SUNNICA ENERGY FARM

EN010106

8.2 Proposed Changes to the Application

Version	Date	Status of Version
Rev 00	30 August 2022	Final

Figure 3-1: Burwell National Grid Substation Extension Options 1 and 2 (See Figure 3-20 of the Application [EN010106/APP/6.3])

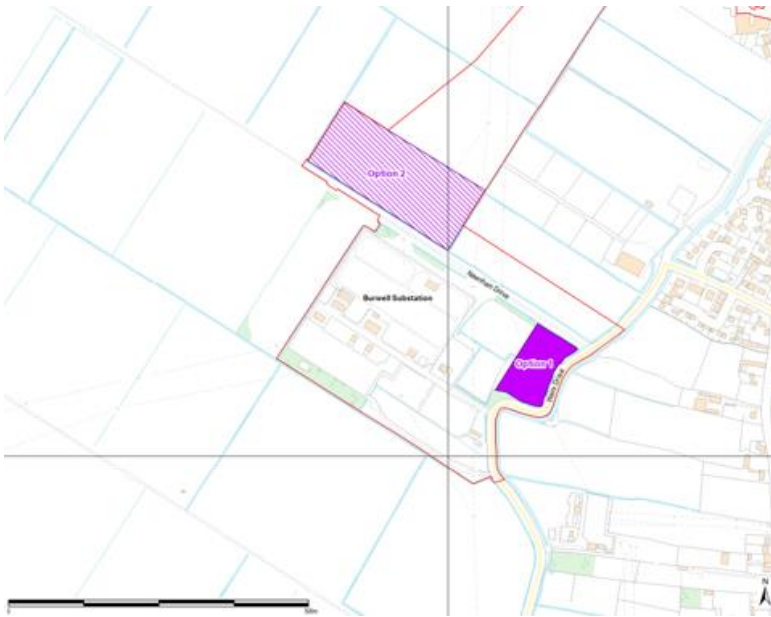
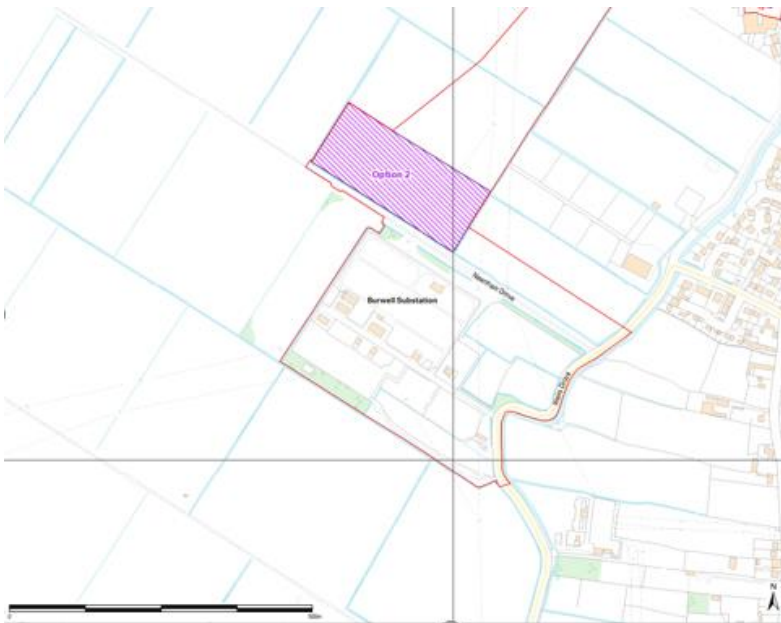
- 3.1.1 The Burwell Substation extension Option 1 is proposed to be removed from the Scheme, although rights through this land may still be required for underground cabling. The need for the transformer compound at this location would be removed by changing the electrical configuration of the Scheme (as set out in NMC-02 and NMC-03) or by proceeding with Option 2 for the substation extension. Figure 3-1 and 3-2 overleaf show the relevant changes.

- 3.1.3 This change is shown on the 'before' and 'after' extracts of ES Figure 3-20 in Appendix J, Sheet 20 of the Land and Crown Land Plans, Works Plans and Access and Rights of Way Plans as shown in Appendix I of this report.

Figure 4-2: 400kV Cable Route Cross Section

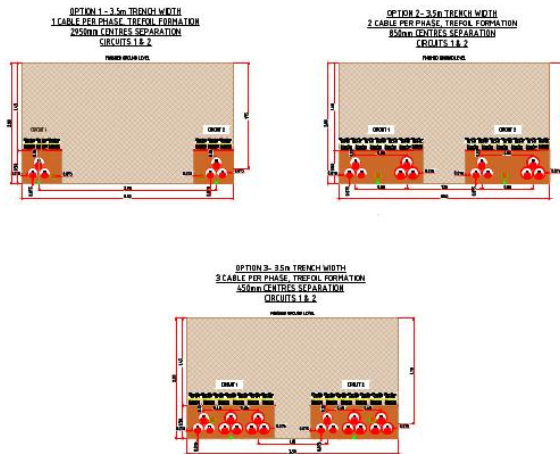
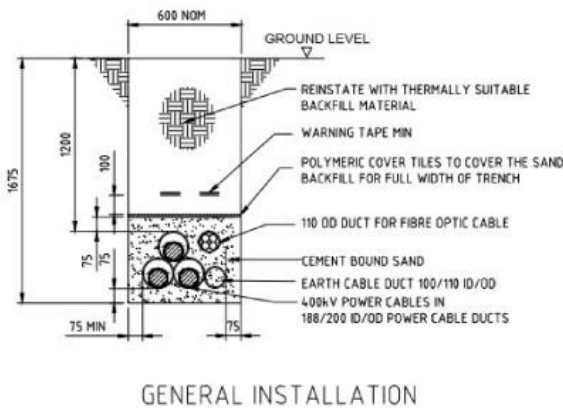
- 4.1.1 Option 3 would require that the electrical configuration for the main import and export electrical cables that run within Grid Connection Route A and Grid Connection Route B be suitable for 400kV transmission as opposed to the 132kV cables that would be required for Options 1 and 2. This would mean that only a single set of cables will require a trench, jointing bays, horizontal directional drills as opposed to four, had the cables run at 132kV. This change is within the parameters (such as trench width and depth, working width, location of jointing bays etc. Refer to Chapter 3: Scheme Description **[EN010106/APP/6.1]** for further information) assessed in the ES submitted as part of the DCO application. The construction programme for the Grid Connection Routes A and B will be extended slightly to 50 weeks, from the current proposed 30 weeks; however, this is still within the 24 month worst case construction programme assessed within the ES.

- 4.1.2 Before and after images of the 132kV and 400kV cross sections, illustrating this change, are presented below. The Application figure reference is provided below for information.

Figure 5-2: Proposed General Arrangement – Sunnica West Site A – 400kV solution (Illustrative)

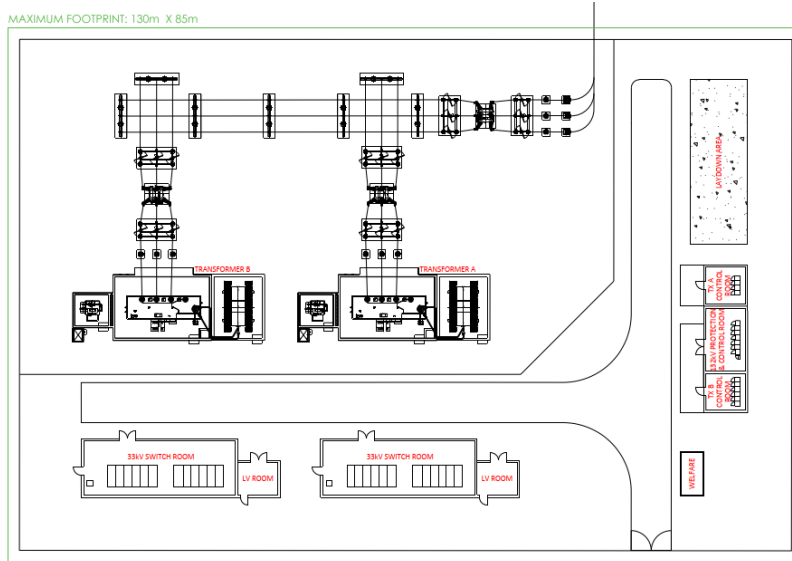
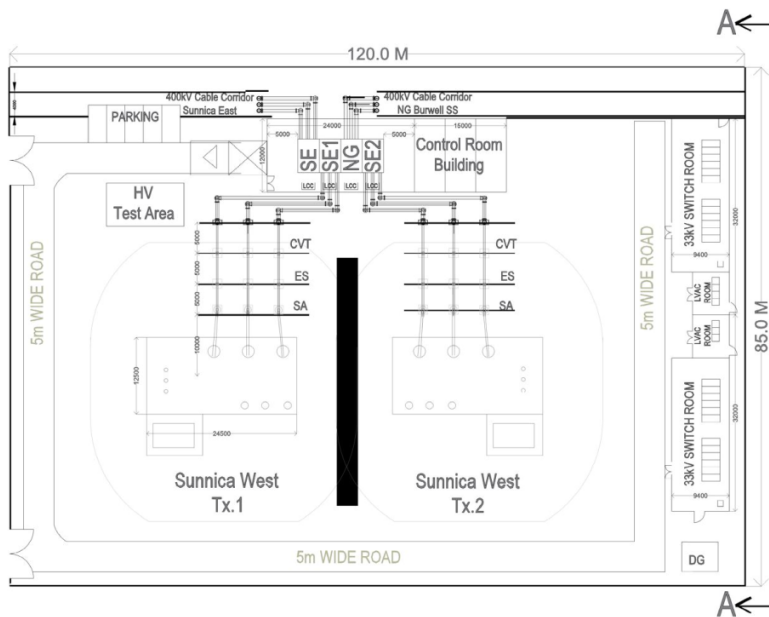
- 5.1.5 Before and after images of the illustrative general arrangement plans are provided below. The Application figure reference is provided below for information.

Figure 5-8: Sunnica West Site A Substation Elevation – 400kV solution (illustrative)

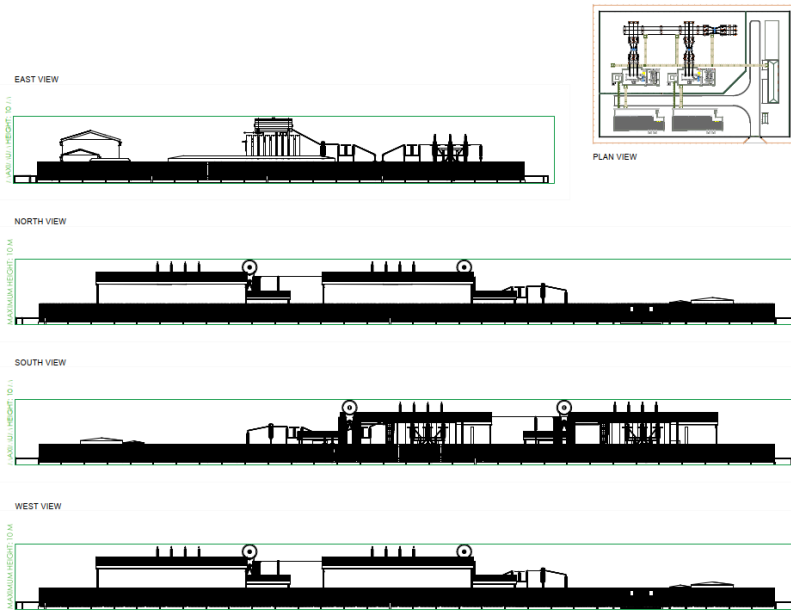
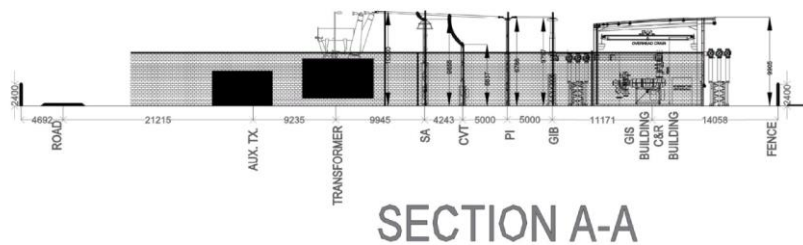
5.1.6 Before and after images of the illustrative elevation plans are provided below in Figures 5-7 to 5-12. The Application figure reference is provided below for information.
